CORPORATION
Crystal River Unit 3
Docket No. 50-302
Operating License No. DPR-72

Subject: License Amendment Request #241, Revision 0
High Pressure Injection System Modifications

**LICENSE AMENDMENT REQUEST #241, REVISION 0
HIGH PRESSURE INJECTION SYSTEM MODIFICATIONS**

Figure 1

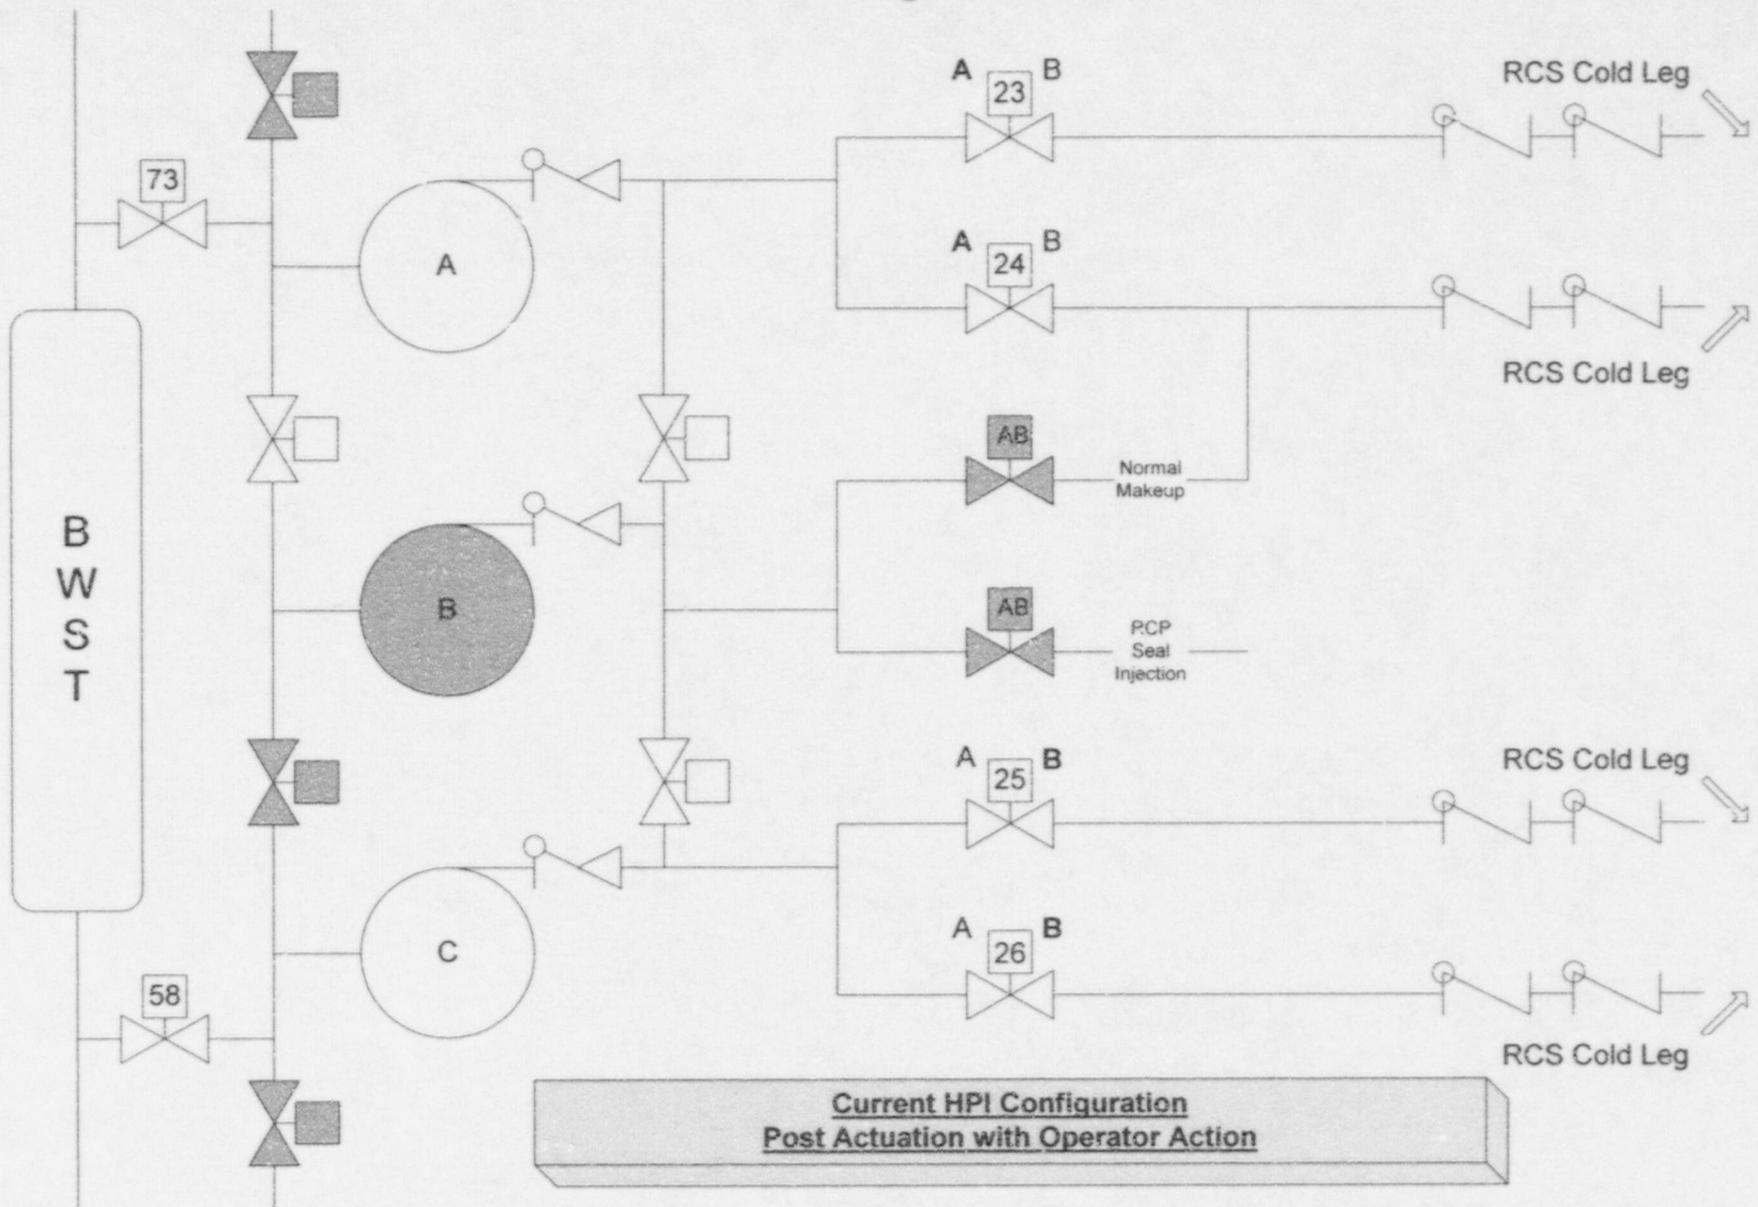
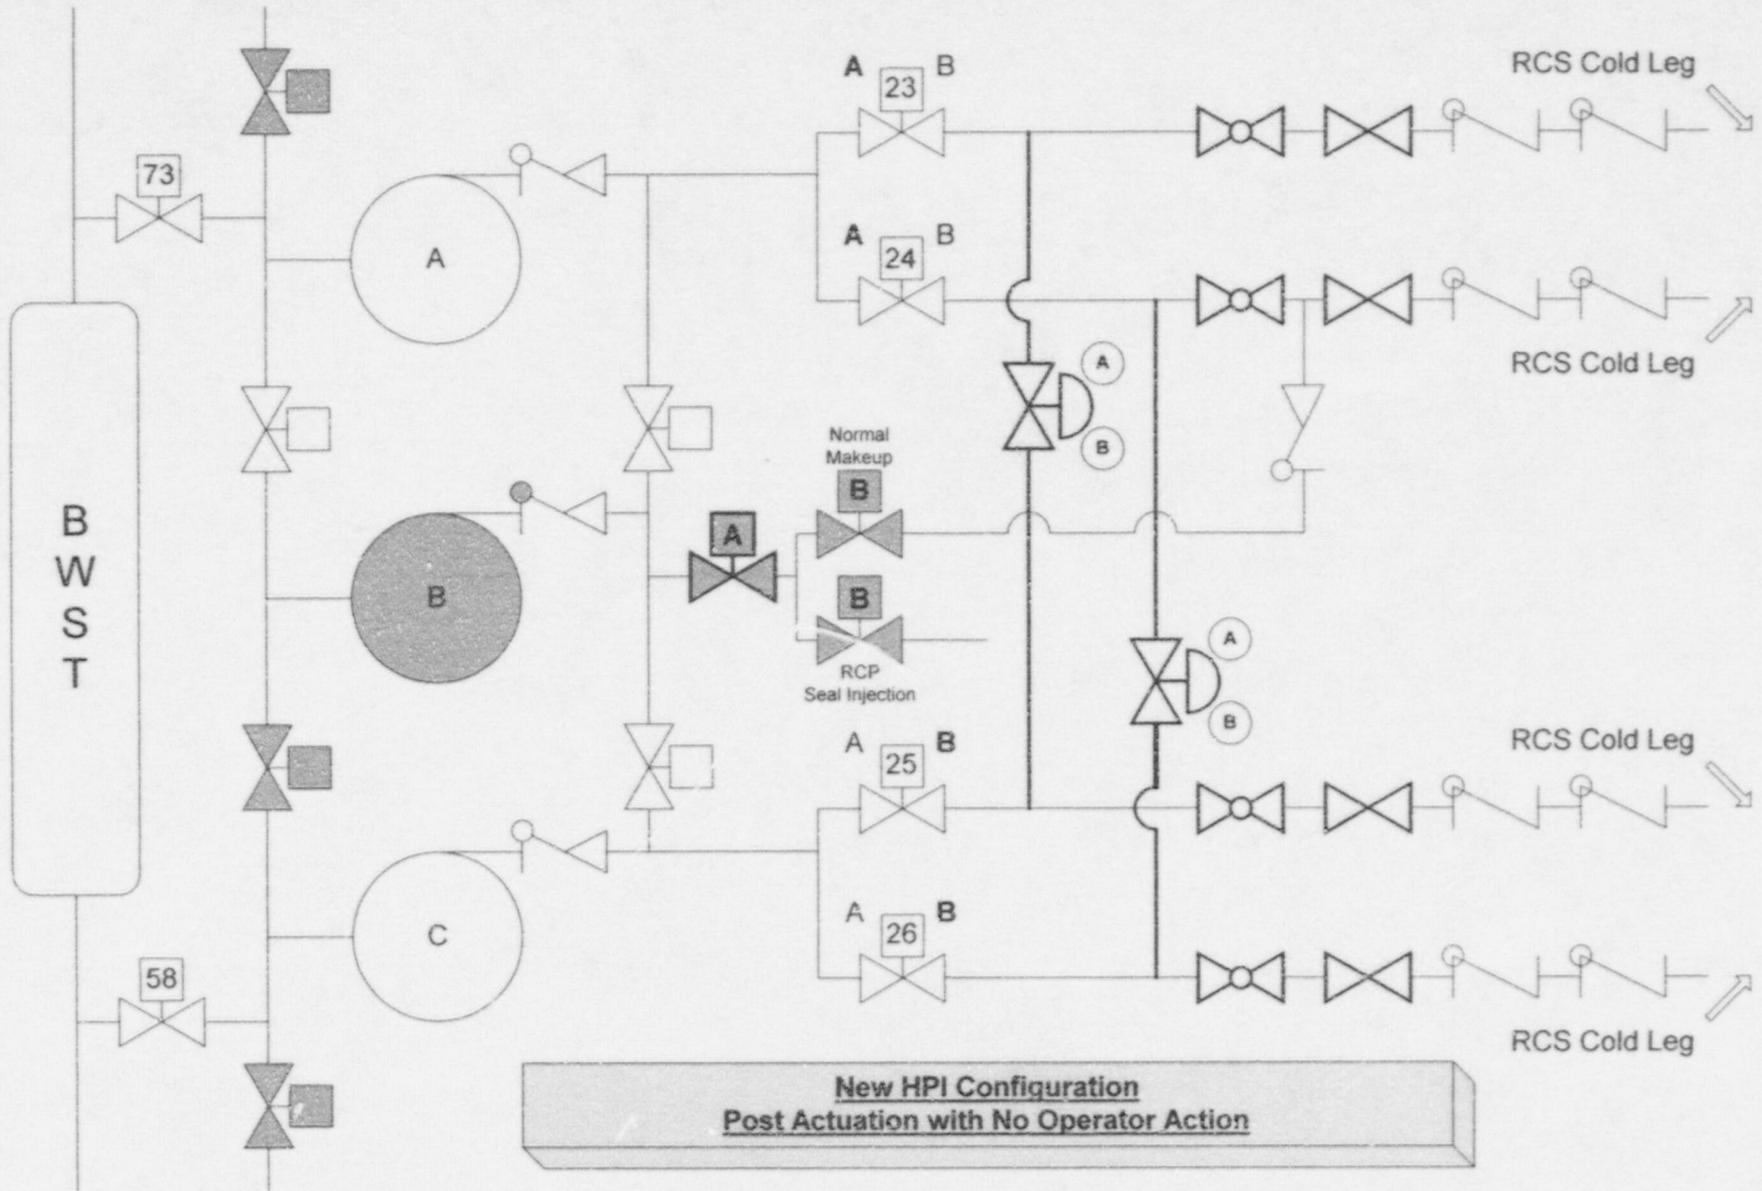
- Cross-tie lines will be installed downstream of the HPI control valves. Each of the two cross-tie lines will contain a single air operated block valve that will receive an open signal from both ES actuation trains. This assures HPI flow will be directed through all four HPI lines at the time an ES actuation occurs without operator action. This automatic action will improve PCT for the worst case SBLOCA.

- A new "A" train powered motor operated valve will be installed in the common line that supplies normal makeup and RCP seal injection. The existing normal makeup isolation and RCP seal injection isolation valves will be configured to receive power from the "B" train electrical system. All three valves will close on an ES signal to ensure normal makeup and RCP seal injection flow will be isolated even with a single failure. Operator action will no longer be required other than to verify that these flow paths have been isolated as part of standard ES actuation verification.
- Pre-set throttle valves will be installed in each HPI line downstream of the cross-tie lines. These valves will establish an HPI flow balance that eliminates the need to recognize and isolate an HPI line break.

Figure 3

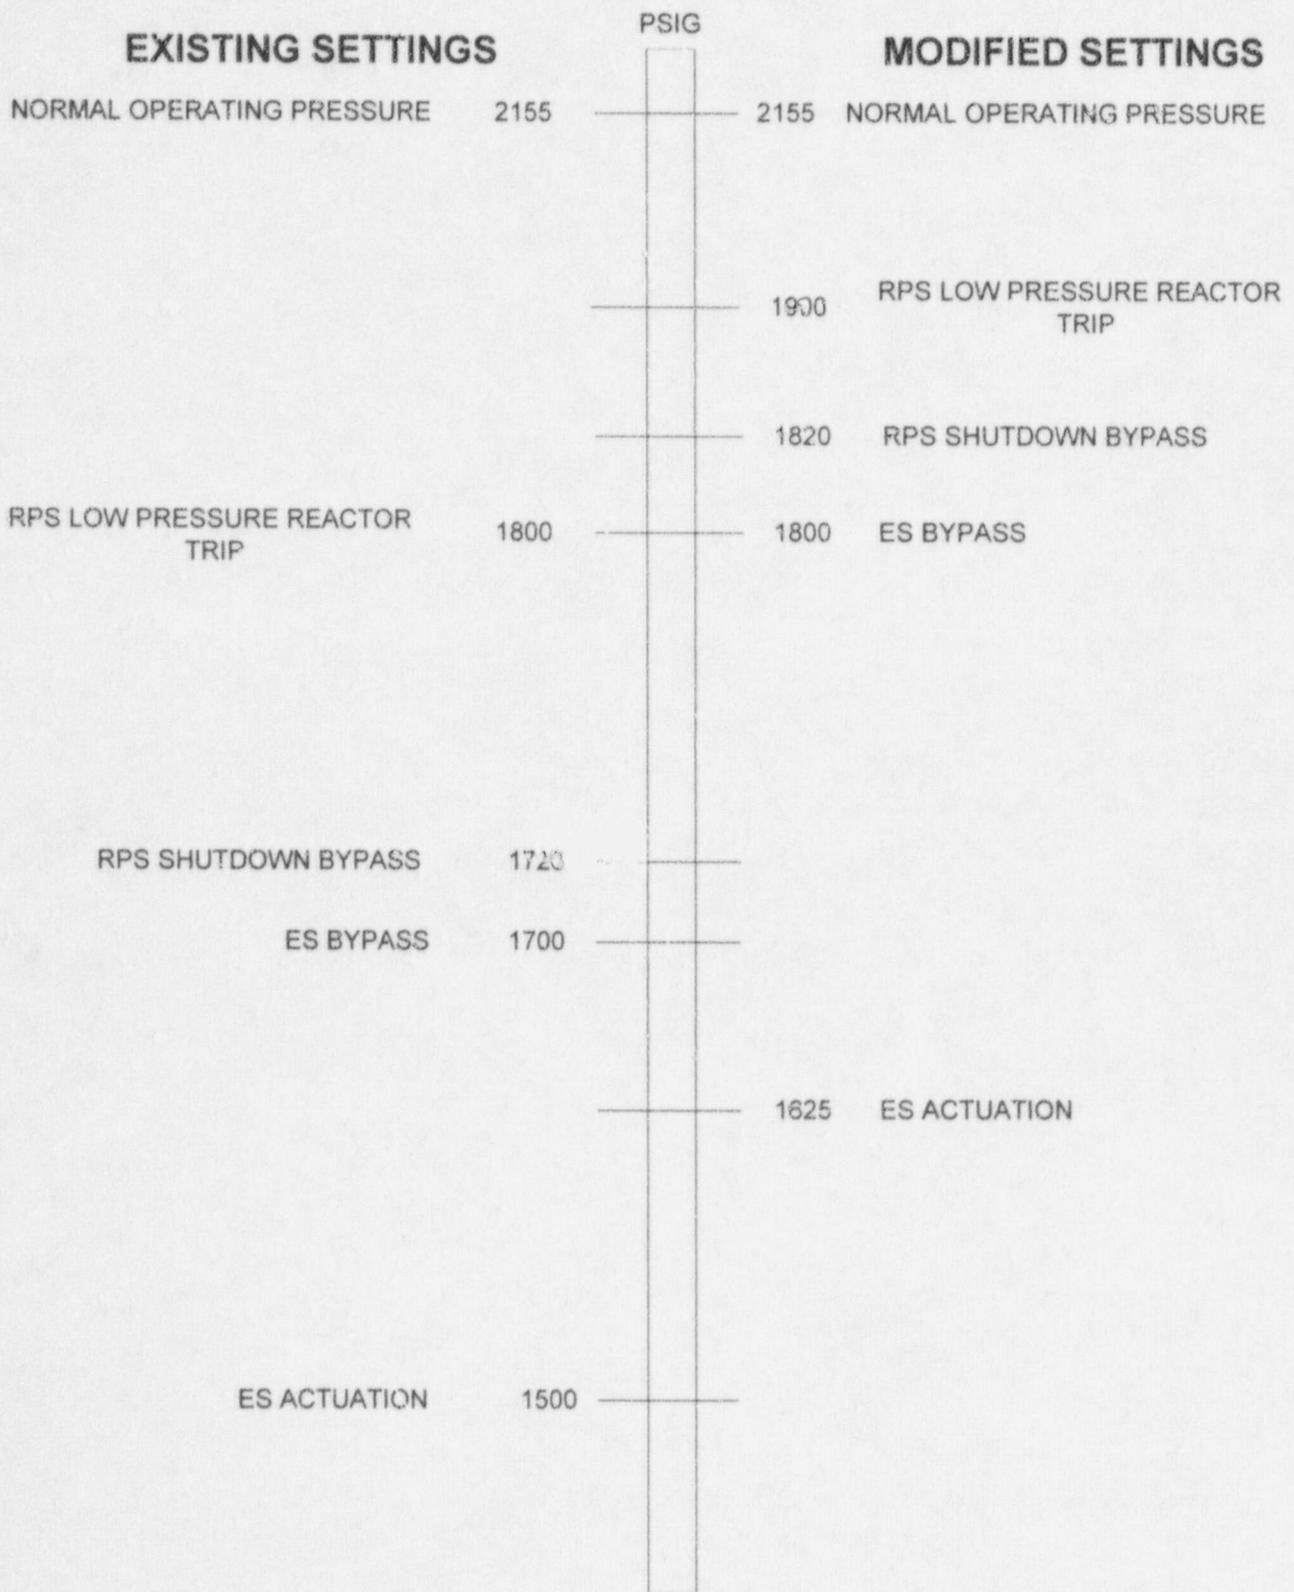
- Raising the ESAS setpoint for HPI actuation from 1500 psig to 1625 psig

The RCS low pressure ESAS setpoint will be changed from 1500 psig to 1625 psig. This change will provide for earlier actuation of HPI and will result in lower PCT values for smaller size SBLOCA cases. For larger SBLOCA transients, depressurization will occur more rapidly and the higher actuation setpoint will have no significant impact.

The applicability requirement for ESAS OPERABILITY will be changed from above 1700 psig to above 1800 psig. The HPI ESAS can be bypassed when RCS pressure is below the applicable condition. A graphical representation of the setpoints is included as Figure 3, Page 9 of 9.

In order to maintain plant operating margins, the RCS low pressure reactor trip setpoint will be raised from 1800 psig to 1900 psig. A review of industry data shows that an RCS low pressure reactor trip setpoint of 1900 psig is in use at other Babcock and Wilcox (B&W) reactors and is well within the range of setpoints found for other pressurized water reactors.

The Shutdown Bypass (RCS High Pressure) reactor trip setpoint will be raised from 1720 psig to 1820 psig. This change will allow selecting shutdown bypass in the same procedural sequence as it is currently performed (prior to bypassing the HPI ESAS).
